AGENDA DESIGN ADVISORY PANEL MEETING

November 25, 2021, 5:00 PM
Board Room, Service and Resource Centre,
411 Dunsmuir Street, Nanaimo, BC

RESPONSE TO DESIGN ADVISORY PANEL RECOMMENDATIONS

2545 DOCTORS ROAD, NANAIMO

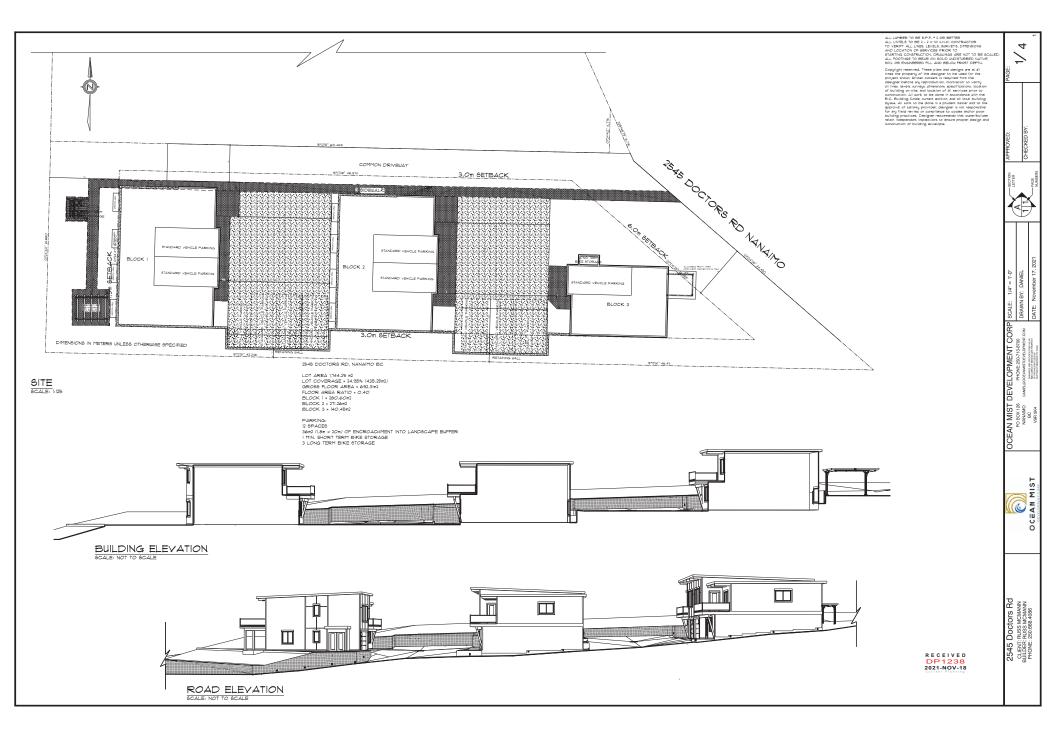
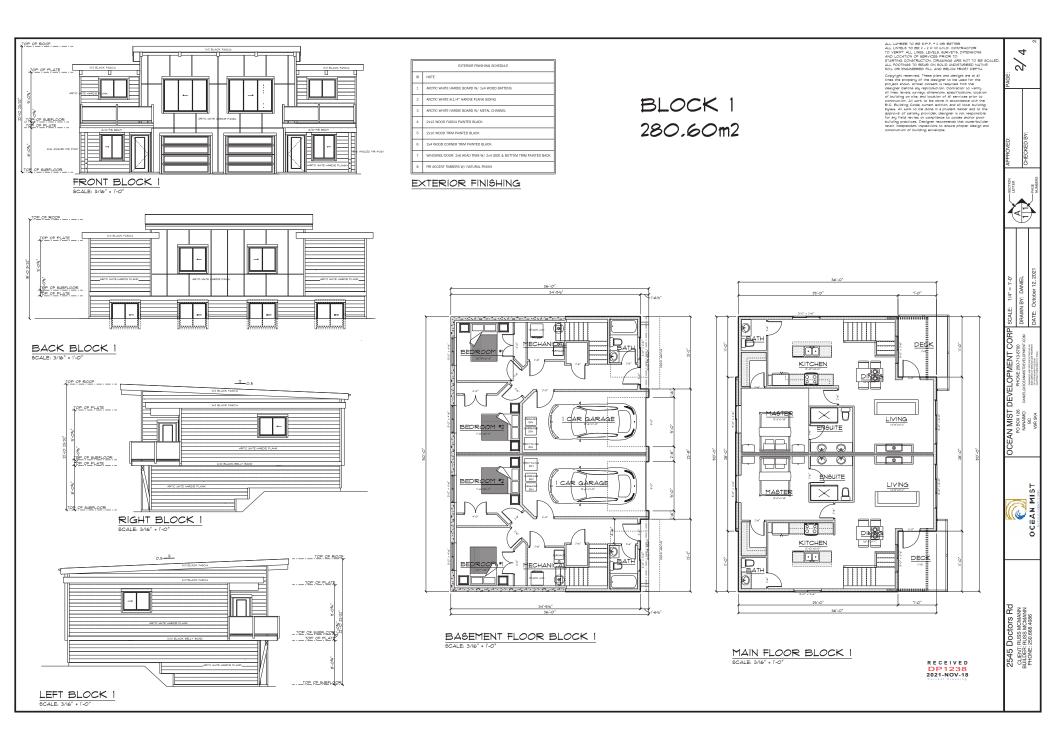
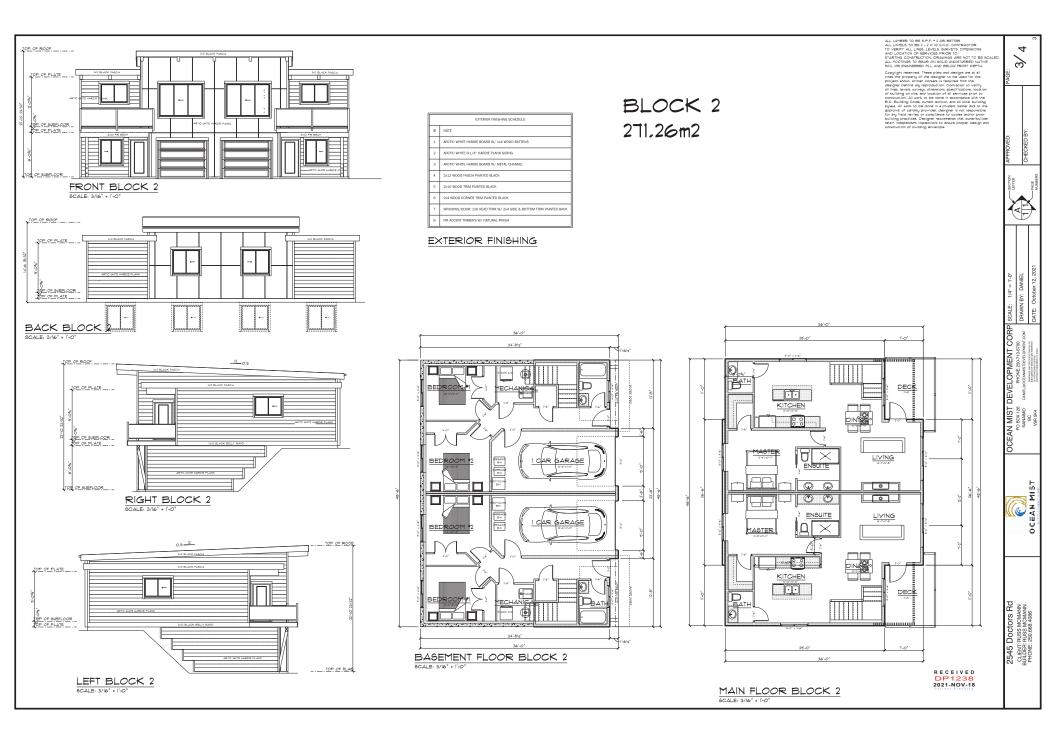
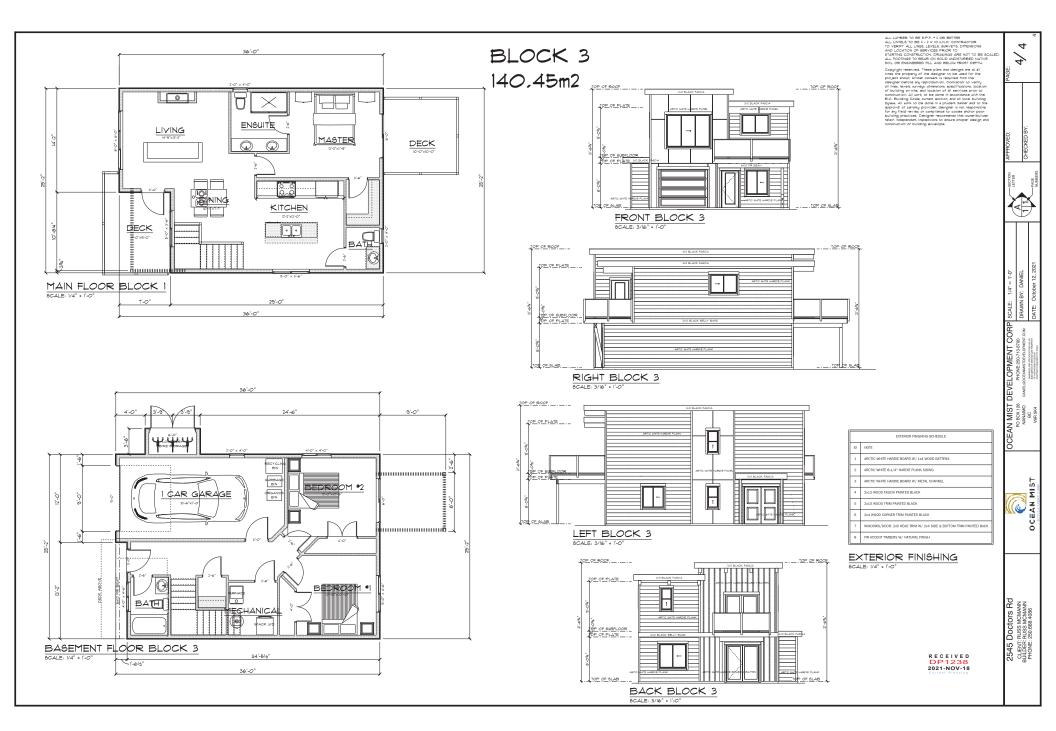
1. Consider additional articulation and variation in materials for all buildings with particular attention to weather protection at building entrances.

Consider increased bio-diversity in plant selection and quantities throughout the site.

3. Provide a more refined landscape plan with a focus on pedestrian experience.

4. Consider a variation in texture, material, and pattern for the paved areas.

5. Take cues for the form and character and landscape design from the surrounding neighborhood.

6. Provide more details regarding the height and materials for the proposed retaining walls.

7. Consider enhancing the amenity area with trellises and further landscaping.

8. Provide information regarding site lighting.

Deck extensions have been added to all Blocks to provide better weather protection at all building entrances. Angled post and beam deck supports add additional variation of materials to the entrance as well.

Increased quantities and bio-diversity of plantings. Focus was given to flowering species for visual interest, and to attract bees and insects.

Landscape plan has been revised to the suggestions and advice of committee by adding defined paver stamped concrete pathways with lighting, increased bio-diversity, seating area, and easily accessible short-term bike storage.

Pedestrian walkways have been changed to paver style stamped colored concrete. This aids in understanding flow paths through the site.

Plant selection has been updated and influenced by surrounding landscape.

Maximum retaining wall height is 1.5m for all locations with a width of 0.2m. Retaining walls consist of form lined colored concrete which give a realistic rock wall look with the structural benefits of a concrete wall.

A pergola has been added to the rear of block 1, which includes an additional planting bed and short-term bike storage.

Low voltage site lighting has been added to pedestrian walkways and parking area.
